## QUALITY ASSURANCE -- NON-CONFORMANCE REPORT

**Report No:** NCR-000627

<b>Welding</b>	<b>Concrete</b>	<b>Other</b>	
<b>Welding</b>	<b>Curing</b>	<b>Procedural</b>	<b>Bridge No:</b> 34-0006
<b>Joint fit-up</b>	<b>Coating</b>	<b>Other</b>	<b>Component:</b> Segment 8CW Floor Beam to Bottom Panel Joint
<b>Procedural</b>	<b>Procedural</b>	<b>Description:</b> Missed MT indication by QC

**Subject:** NCR No. ZPMC-0600

**Reference Description:** One Transverse Indication discovered with MT after ZPMC had tested and accepted this weld in Segment 8CW

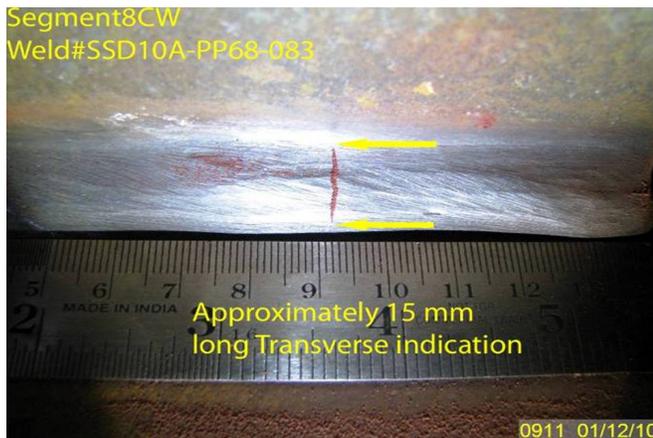
During the Quality Assurance Magnetic Particle Testing (MT) review of welds located on Segment 8CW, this Quality Assurance Inspector (QA) discovered the following issue:

- One (1) Transverse linear indication measuring approximately 15mm in length.
- The Y location is 140mm from the left end of the weld.
- The indication is clearly marked on the material near the weld.
- The weld is identified as: SSD10A-PP68-083.
- This weld is a Fillet Weld joining the Bottom Plate (BP150A) to Floor Beam (FB5B) web plate.
- This weld is designated as Seismic Performance Critical Member (SPCM) on the approved drawing (SEGSD10).
- OBG segment 8CW is located outside in west of Blast Shop area.

The Notice of Witness Inspection Number (NWIT) is 005037. The indication is located inside the area that has been previously tested and accepted by ZPMC Quality Control (QC) personnel. ZPMC's QC personnel are required to perform twenty five (25%) percent MT inspection of this weld.

**Reference Resolution:** ABF is submitting NDT documentation to show that welds with missed indications are acceptable after repair.

The documentation submitted by the contractor has been reviewed by the Engineer and is found to be acceptable. Based on the discussion in China with the contractor's representatives, other weld repair reports from ZPMC shall be included in the QA Data Base when available.

ABF submitted internal NDT documentation verifying the weld is now in conformance with Contract specifications. Per Team China discussions, documentation from ZPMC verifying the repairs were made and NDT was performed by ZPMC technicians will be submitted at a later date and added to the Data Base.
